Amplifier installation diagram

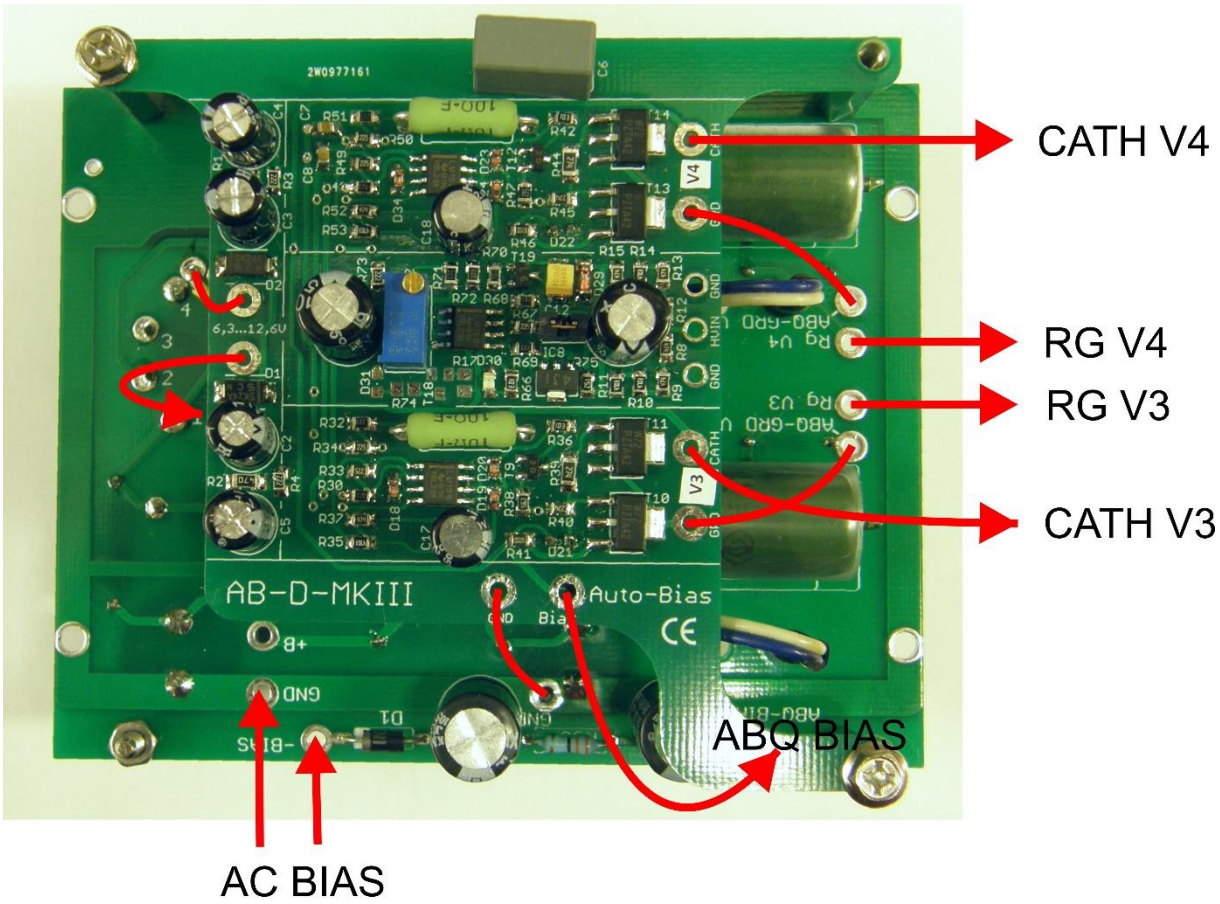
There are no cathode resistors on cathodes V3 and V4.
Cathodes V3 and V4 are connected directly to AB-Q-MKIII.

Schematic diagram

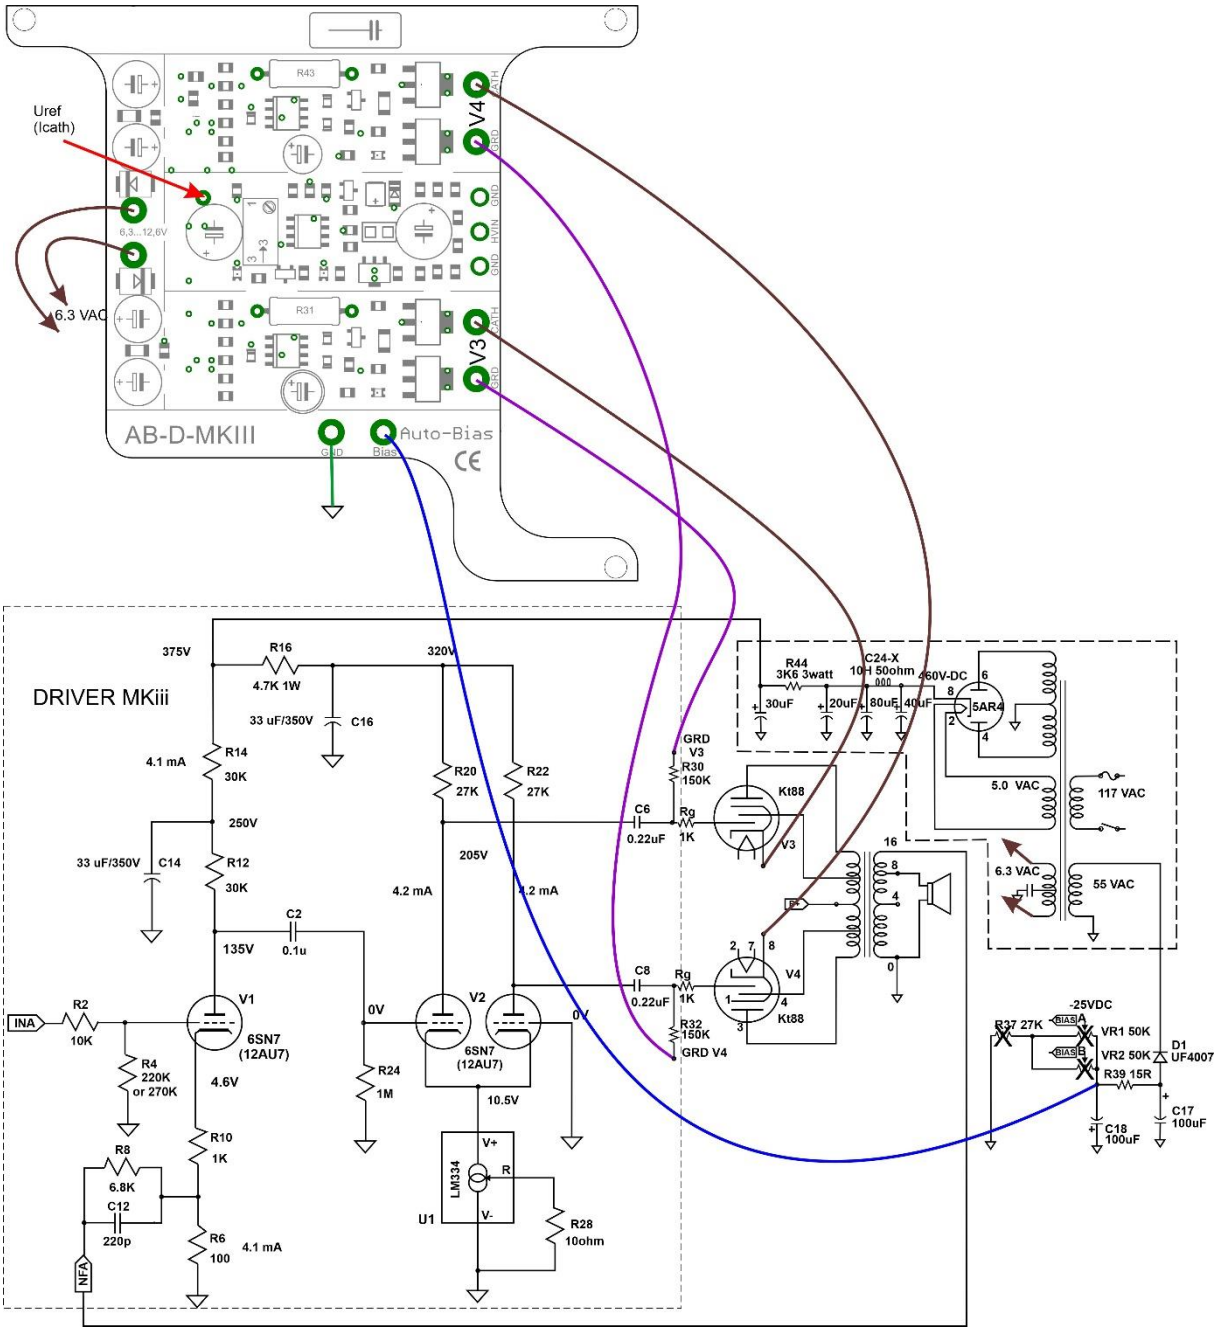
Resistor R39 in the bias source must be replaced with a value of

15 Ohm
